HOLTEC INTERNATIONAL

HI-STORM 100 CERTIFICATE OF COMPLIANCE 72-1014

LICENSE AMENDMENT REQUEST 1014-1

April 25, 2000

FIGURE 2.1-1
FUEL LOADING REGIONS - MPC-24

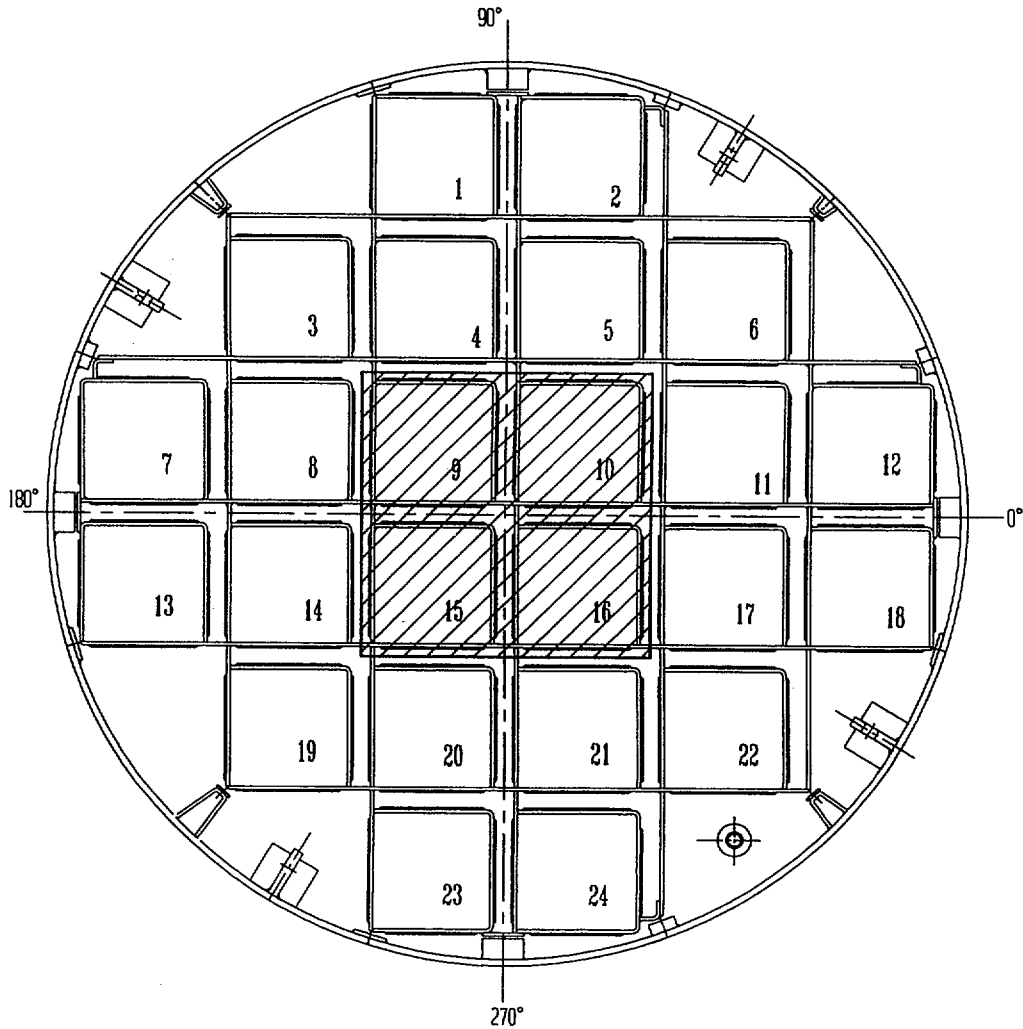
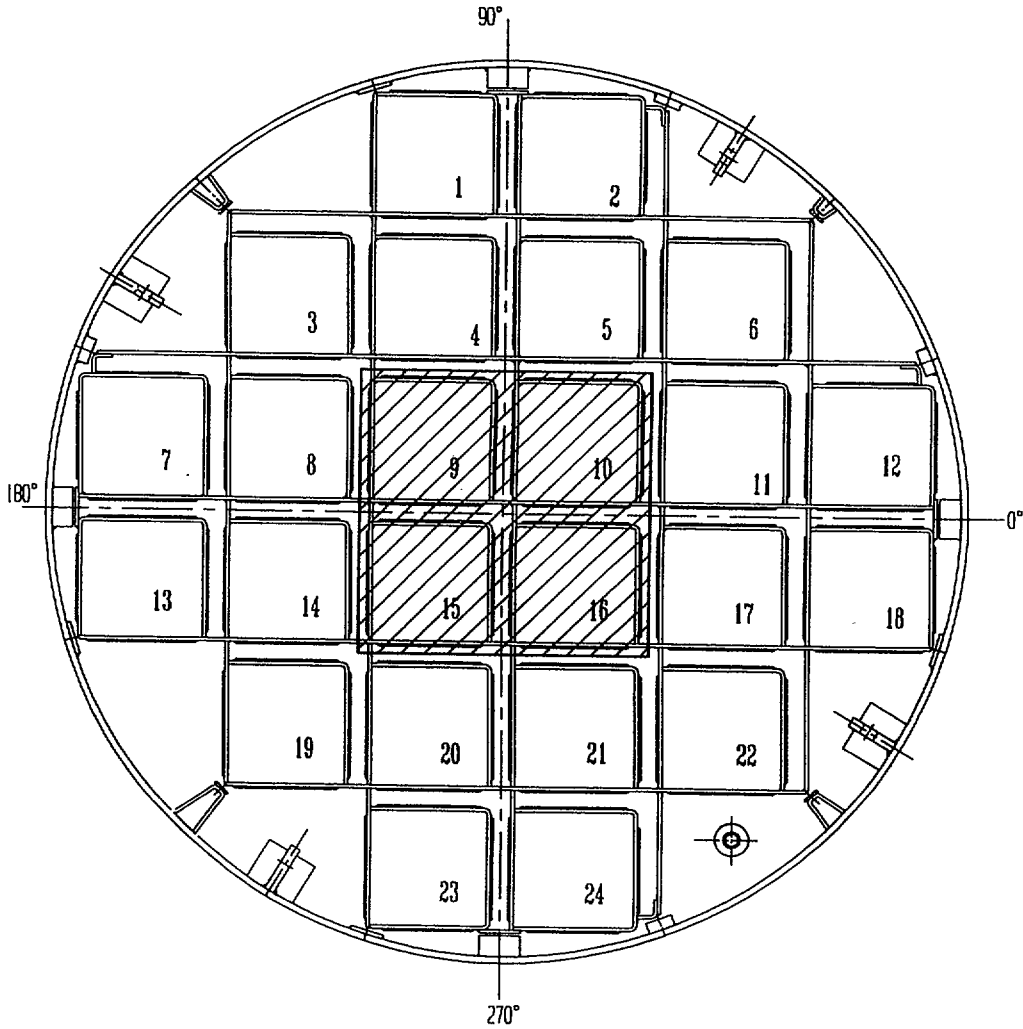
- a. Subsection 2.1.2 is revised to state that preferential loading is applicable during uniform loading (which is also defined) and to state that regionalized loading meets the intent of preferential loading.
- b. New Subsection 2.1.3 and Figures 2.1-1 through 2.1-4 are added to introduce regionalized fuel loading as an option. Specific cooling time, burnup, and decay heat limits for regionalized fuel loading are specified in Tables 2.1-6 and 2.1-7 in the Approved Contents section of Appendix B to the CoC.

- a. Clarification to distinguish between uniform fuel loading and regionalized fuel loading and to clarify that regionalized loading meets the intent of preferential fuel loading.
- b. Regionalized fuel loading, in accordance with Figures 2.1-1 through 2.1-4 and Tables 2.1-6 and 2.1-7, as applicable, allows users to load relatively higher heat emitting fuel assemblies than would otherwise be allowed using uniform fuel loading.

FIGURE 1.1.1A; HI-STORM 100S OVERPACK WITH MPC PARTIALLY INSERTED

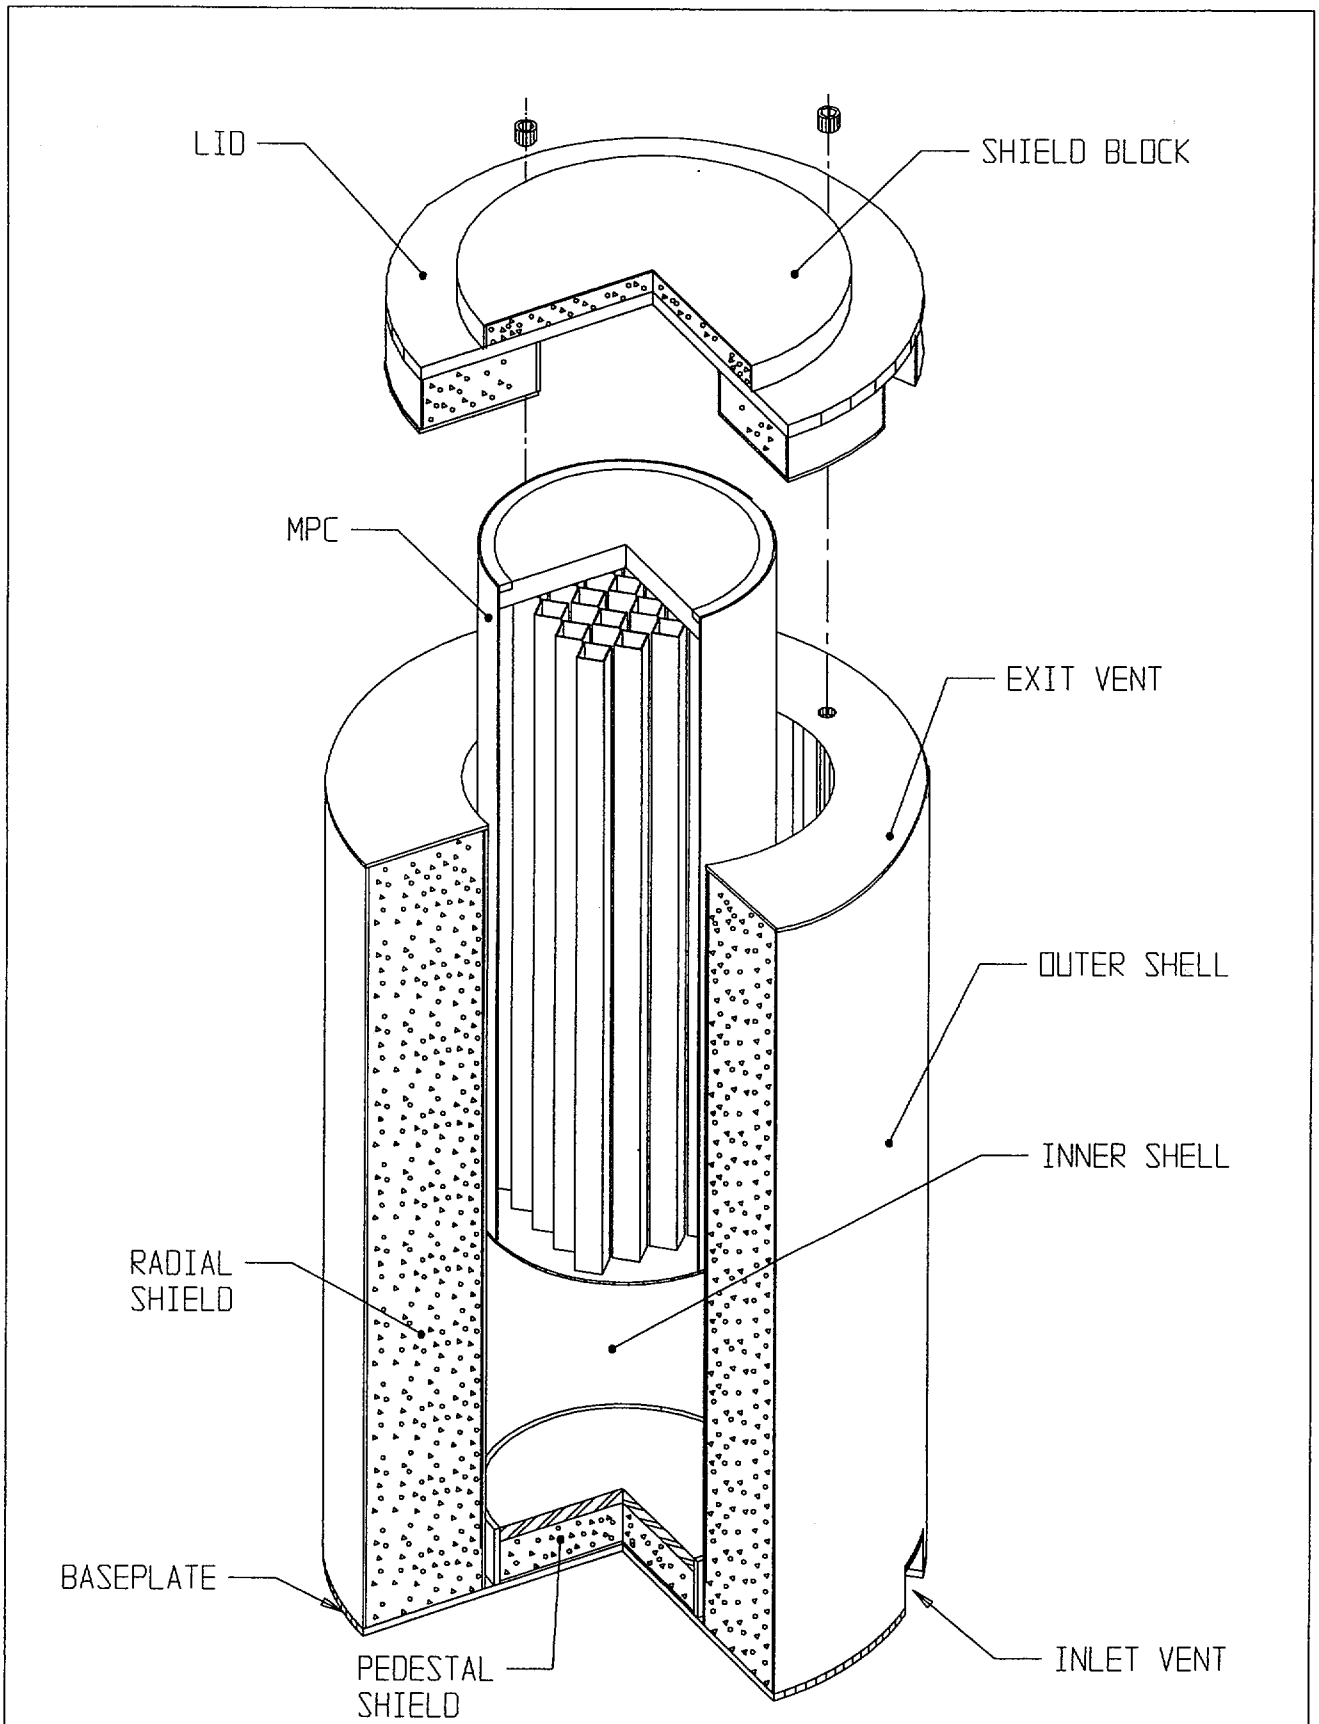
- f. New Figures 1.1.1A and 1.1.3A are added to depict the HI-STORM 100S overpack.
- g. Subsection 1.2.1 is revised to add a footnote that clarifies that the dimensions cited in the text of this section are nominal.

FIGURE 1.2.1A; CROSS SECTION VIEW OF THE HI-STORM 100S SYSTEM

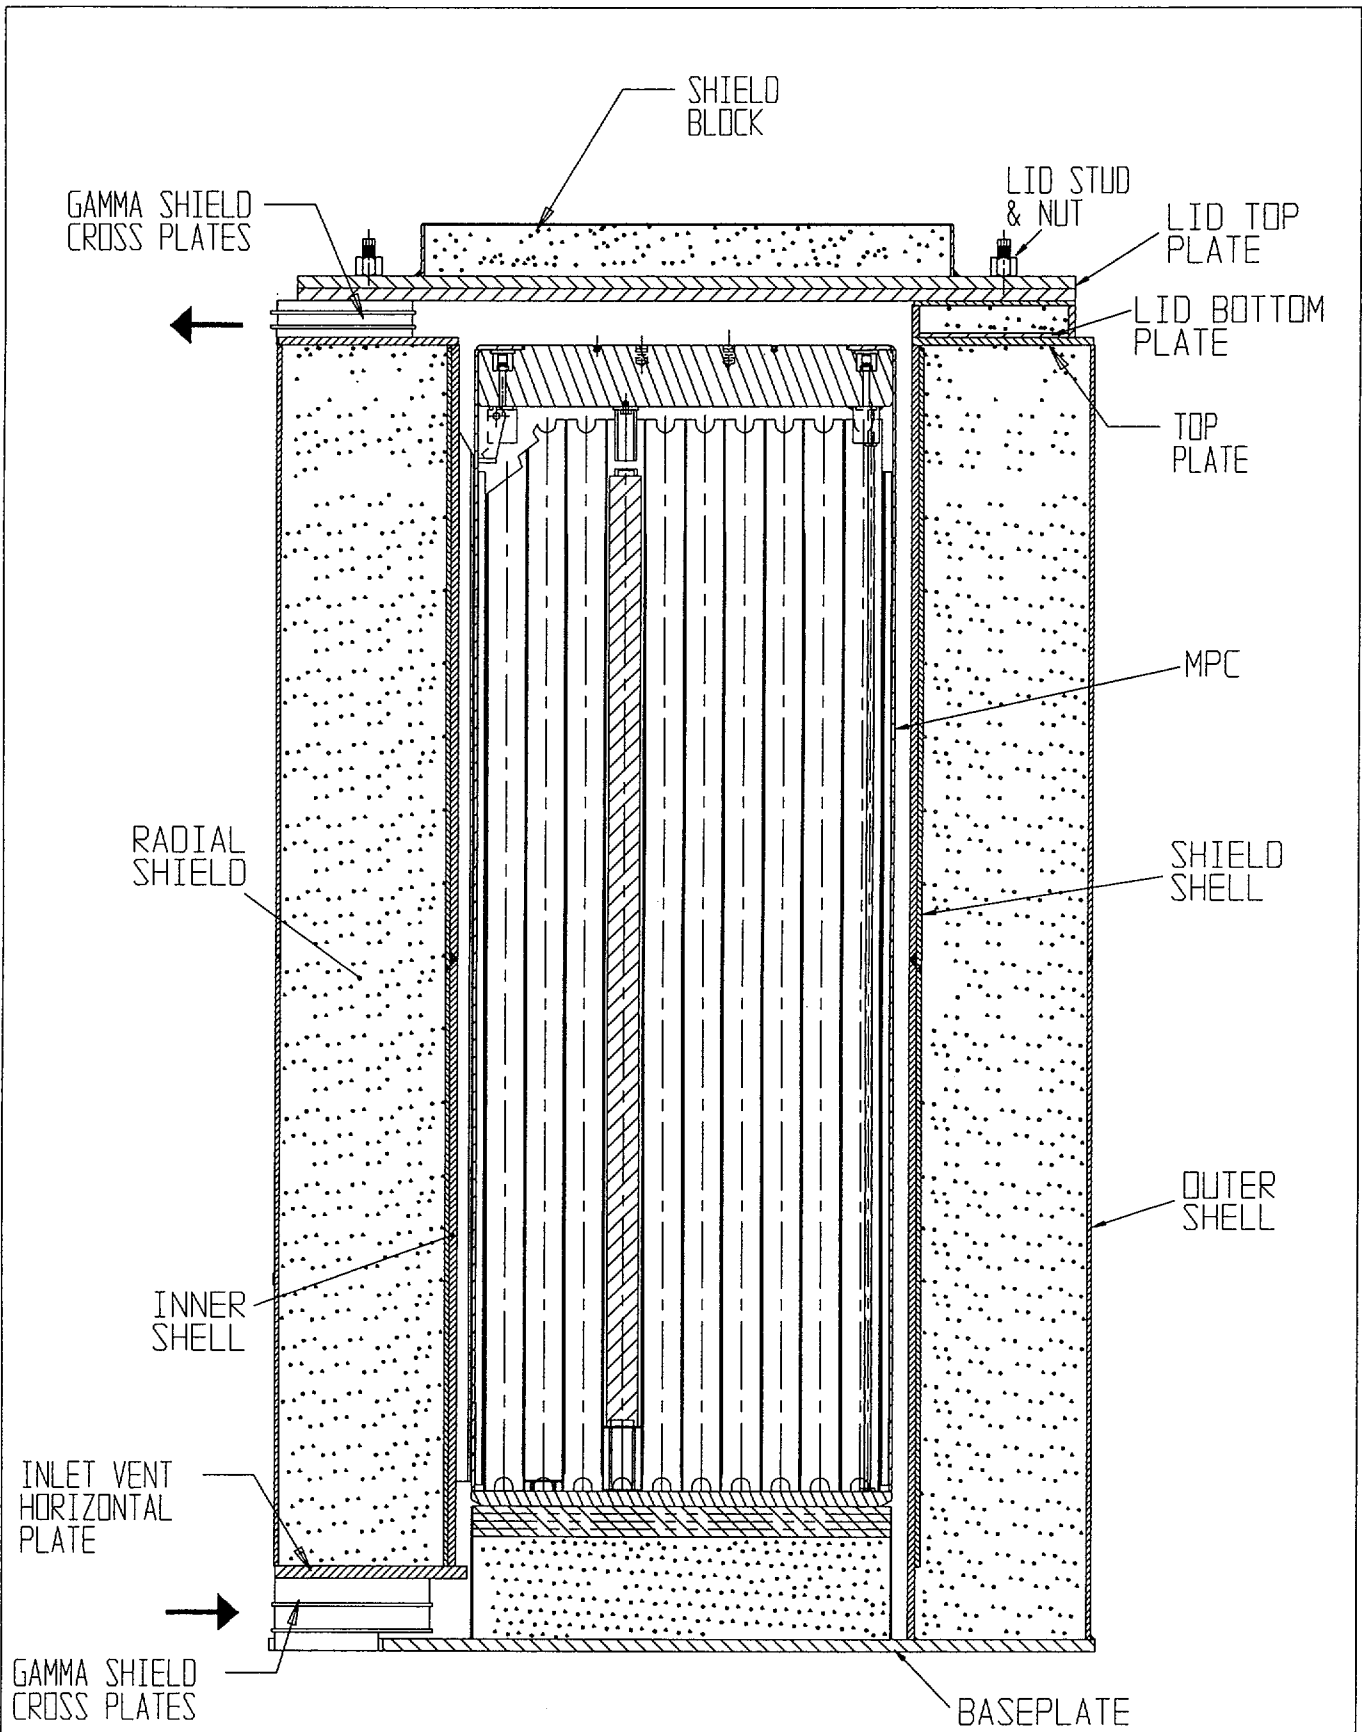
- r. Figures 1.2.1A, 1.2.3, 1.2.4A and 1.2.8A are added.
- s. Subsection 1.5 is revised as follows:
 - 1) New and revised Holtec Design Drawings are added to Section 1.5 to reflect the addition of three MPC models, the addition of the optional HI-STORM 100S overpack; and fabricability enhancements for the previous MPC models, the standard HI-STORM 100 overpack and the HI-TRAC transfer casks and lids.

- r. Figures 1.2.1A and 1.2.8A are required to show the HI-STORM 100S overpack design. Figure 1.2.3 shows the MPC-32 basket layout and Figure 1.2.4A shows the MPC-24E basket layout.

Figure 2.1.3; PWR Axial Burnup Profile with Normalized Distribution

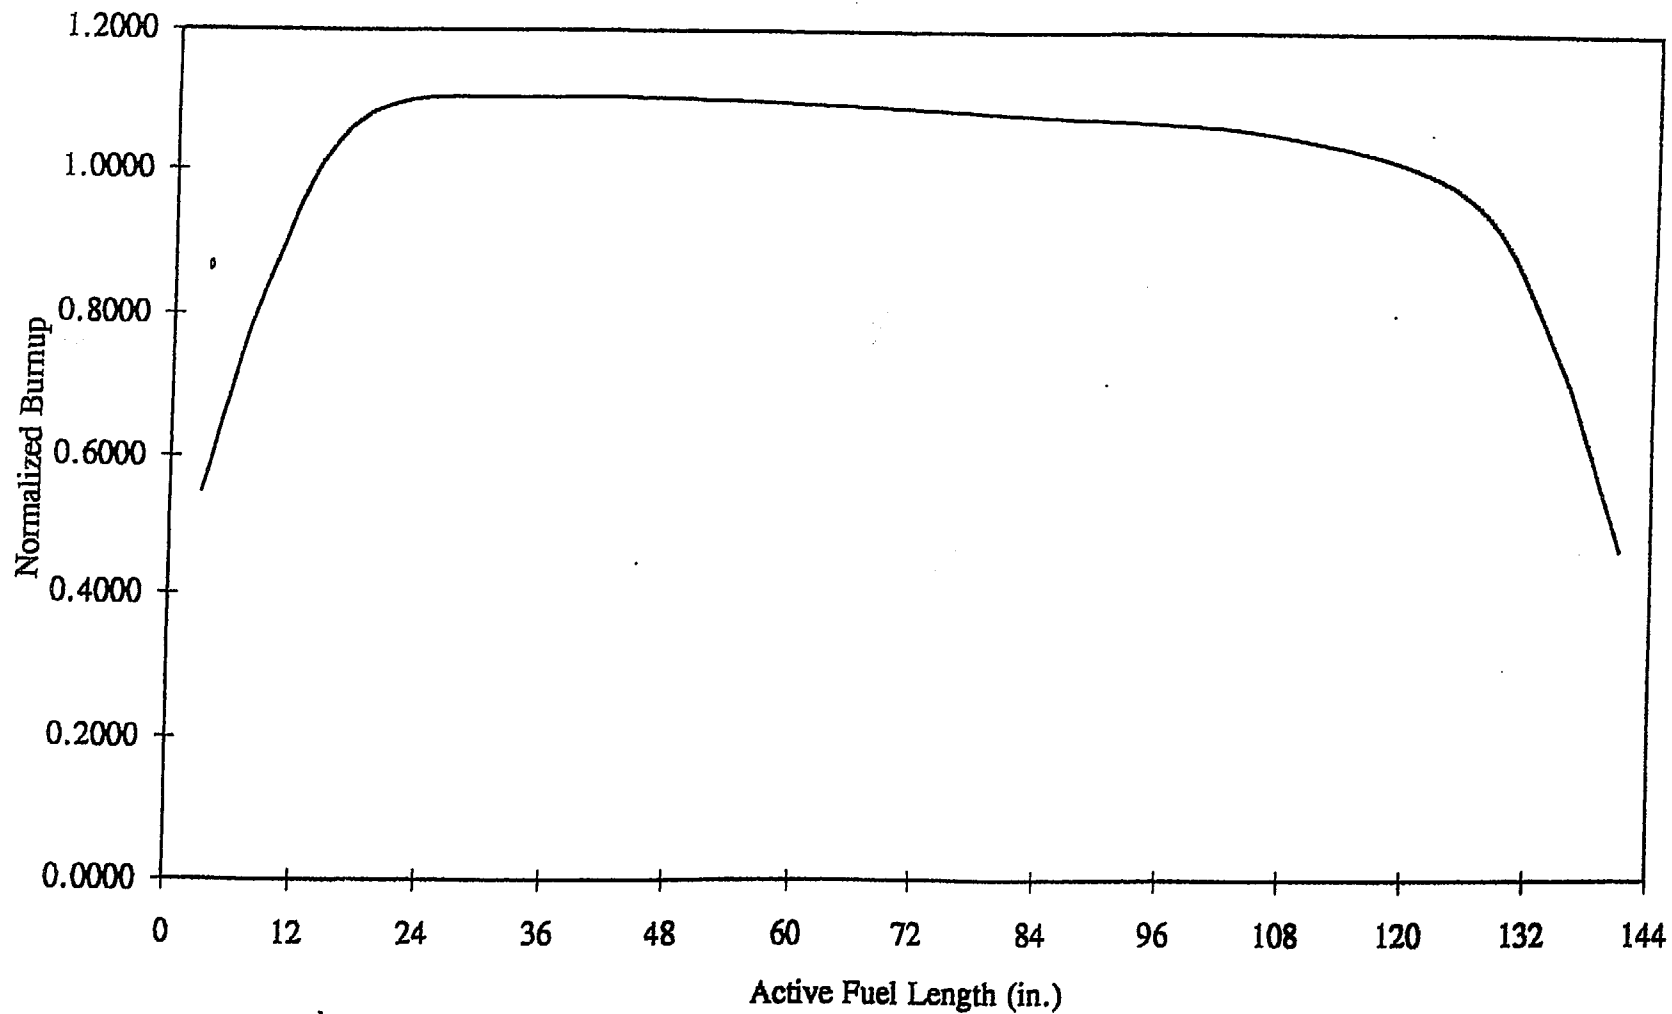
- z. Figures 2.1.3 and 2.1.4 are revised to delete the proprietary note in the footer.
- aa. Figure 2.1.6 is deleted.
- bb. Subsection 2.2.1.2 is revised to reflect a change to the CoC to clarify that the minimum ambient temperature for loading operations applies to the local working area.
